UNITED STATES PATENT AND TRADEMARK OFFICE

| Office Action Summary | Application No. 10/583,901 | Applicant(s) SCHIAVON ET AL. | |

DETAILED ACTION

Claims 1-18 and 23 are pending as amended 3/18/11. Claims 1 and 23 are independent.

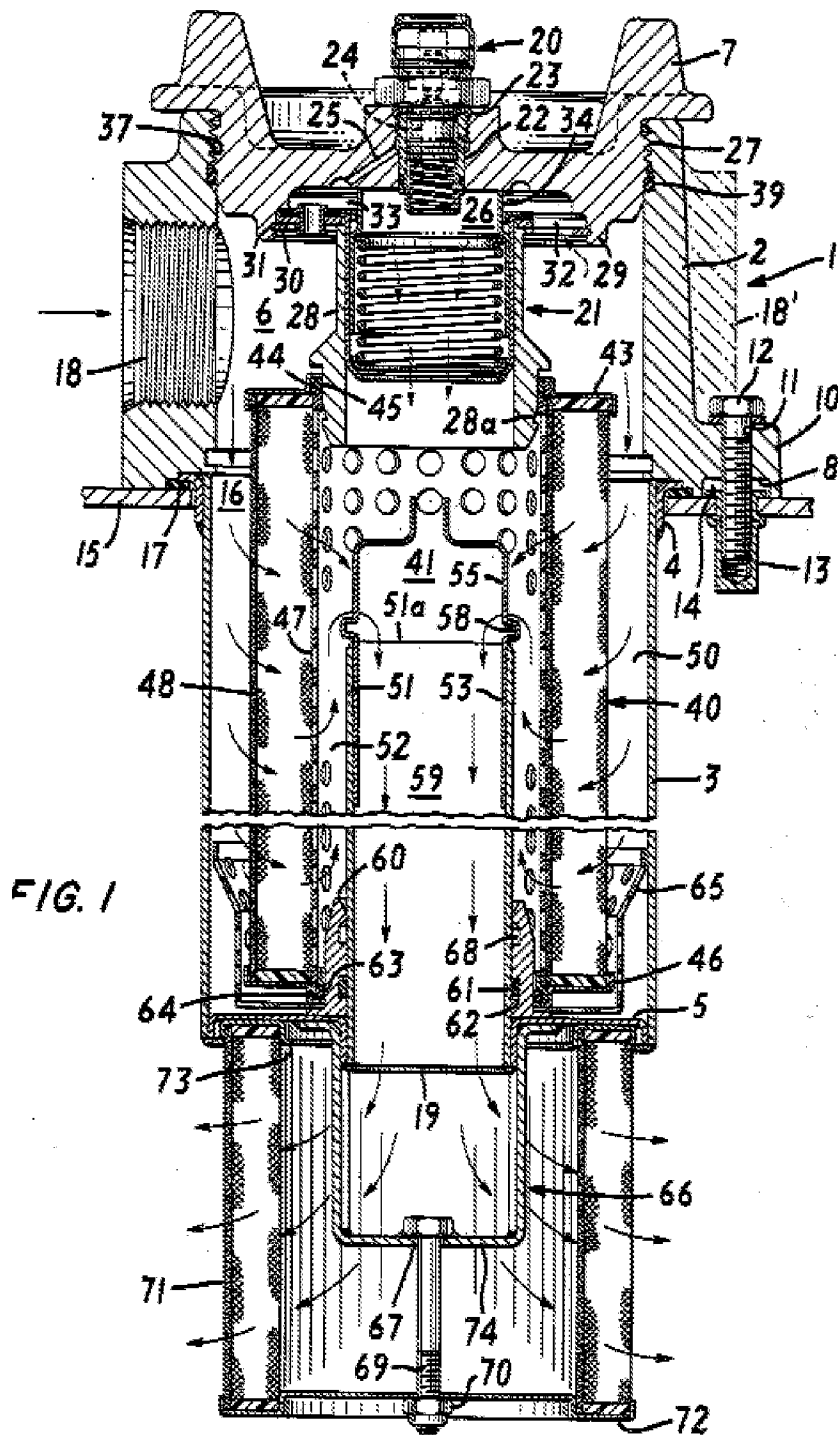
Cooper's fig 1 is copied herein. Cooper teaches a primary filter element (48), secondary (bypass) filter element (71), an end cap (5) there-between, the end cap having a tube (51/53) projected within and parallel to the axis, a seal (61) in a seal member surrounding the tube, a perforated tubular support within the primary filter, a second end cap at the opposite end of the primary filter (43) which has a tube extending from it for connection to the housing top, and having a seal (45) on a seal plane which is having a slight angle as can be visualized from (28a). The structural member (66) is received in a radial slot defined by the first end cap and the filter end (73).

Cooper does not teach the seal (45) at the second end cap as being at an angle to the axis. However, providing an appropriate draft angle for the seal plane at (28a) would be within the skill of one of ordinary skill in the art. In *Gardner v. TEC Systems, Inc.*, 725 F.2d 1338, 220 USPQ 777 (Fed. Cir. 1984), cert. denied, 469 U.S. 830, 225 USPQ 232 (1984), the Federal Circuit held that, where the only difference between the prior art and the claims was a recitation of relative dimensions of the claimed device and a device having the claimed relative dimensions would not perform differently than the prior art device, the claimed device was not patentably distinct from the prior art device. In *re Dailey*, 357 F.2d 669, 149 USPQ 47 (CCPA 1966) (The court held that the configuration of the claimed disposable plastic nursing container was a matter of choice which a person of ordinary skill in the art would have found obvious absent persuasive evidence that the particular configuration of the claimed container was significant.).
